Delegated Report

Approval of Details Application

Application no: 20250033

Location: Old Vicarage Church Street Higham Rochester

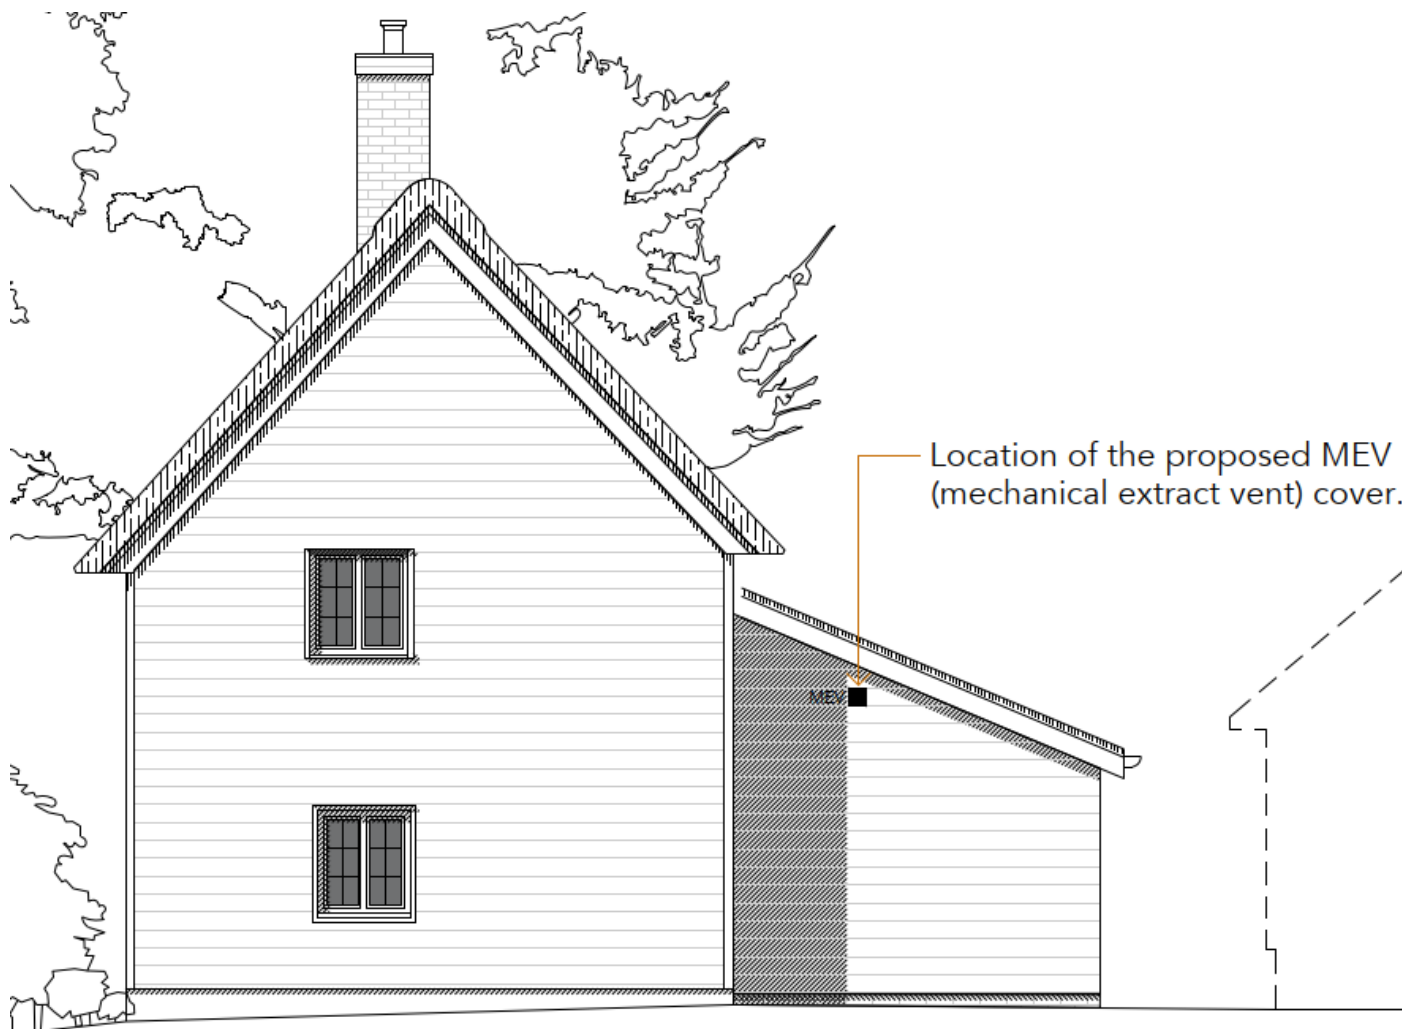
The mechanical extract ventilation (MEV) will terminate onto the east side wall and will have a white plastic cover to match the colour of surrounding weatherboarding as seen below:

A vent in this location is considered acceptable but a plastic cover is not. Plastic is not acceptable on listed buildings as it is an unsympathetic and unauthentic material which would be harmful to the significance of this listed building. A sympathetic proposal would be a decorative cast iron grille.

Due to the white plastic cover proposed for the MEV, the details submitted for condition 5 of listed building consent ref. 20240468 cannot be discharged.

Photograph of existing black plastic on west elevation:

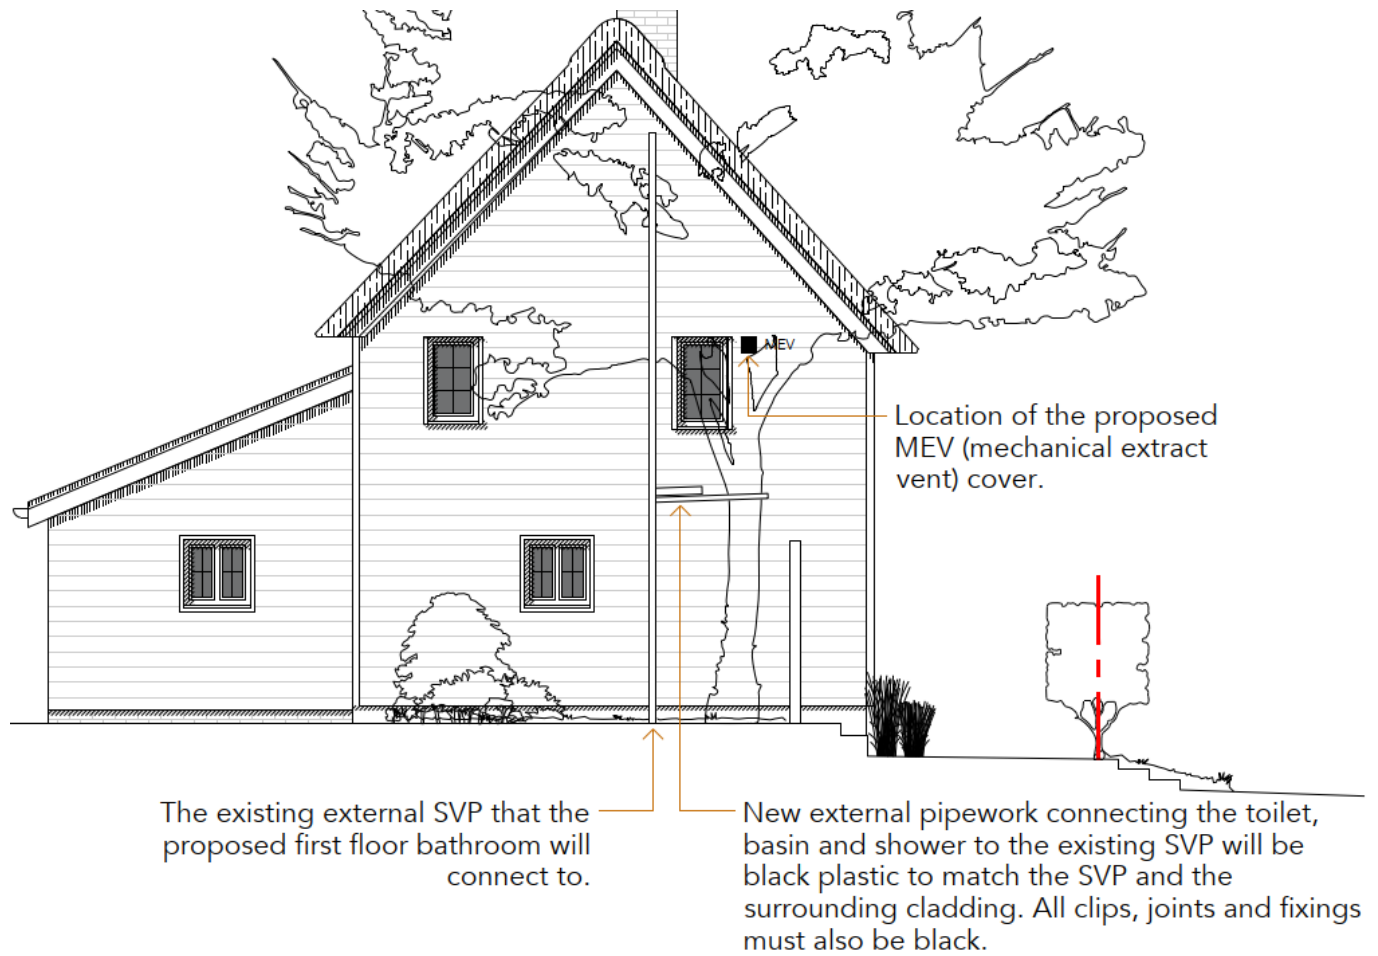
This shows that the drainage for the new bathroom will connect to the existing SVP on the west flank elevation of the building and will be black plastic to match the existing black plastic SVP on that elevation as seen below:

The proposal for additional black plastic pipework as an extension to the existing SVP is considered unacceptable. The use of black plastic pipework on a listed building is not acceptable. It is noted that it is stated that the pipework will match the existing black plastic SVP on the west flank elevation however, there should be no plastic SVP on this building as there is no record of listed building consent being granted for it and as stated above plastic is not a sympathetic or authentic material for listed buildings particularly of this age and character; cast iron would be a sympathetic material.
